Addressing the changes in Table 33-1 for supporting Type 3 and 4 PSEs Inrush.

9 **33.2.7.5 Output current in POWER_UP mode**

19 ***Change the text of 33.2.7.5 as follows:***

Figure 33-13—*Iinrush-2P* current and timing limits, per pairset in POWER_UP

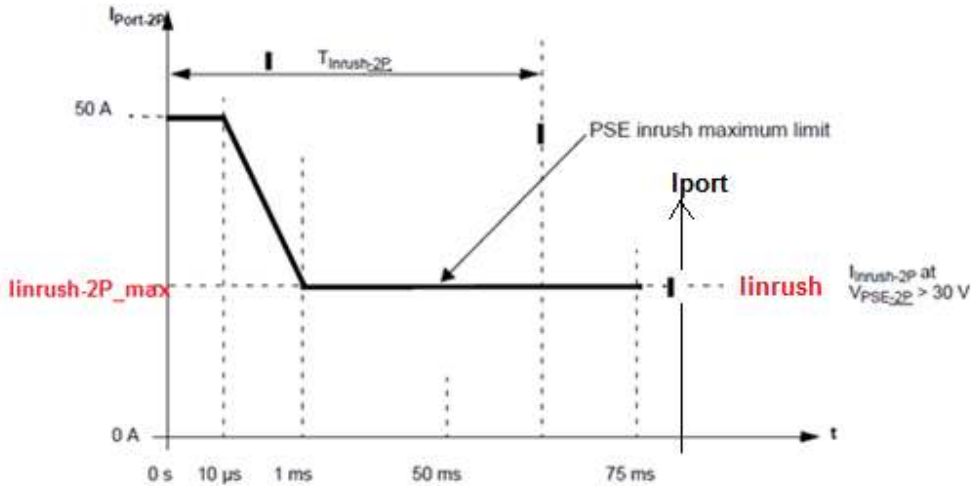
30 Figure 33-13 was modified to address the effect of end to end pair to pair resistance unbalance on the maximum limit of `linrush-2P` which by simulation found to be 0.556A adding margin → 0.6A_{max}. This value will be updated in Figure 33-13 as well to cover requirements below 1msec.

Replace Figure 33-13 with the following:

The PSE inrush maximum limit, *IPSEIT-2P*, is defined by the following segments:

$$I_{PSEIT-2P}(t) = \left\{ \begin{array}{ll} 50.0 & \text{for } 0 < t < 10.0 \times 10^{-6} \\ \text{TBD=function of} & \text{for } 10.0 \times 10^{-6} \leq t < 0.001 \\ \text{(t, linrush-2P_max)} & \\ \text{linrush-2P_max} & 0.001 \leq t < 0.075 \end{array} \right\}_A \quad (33-5)$$
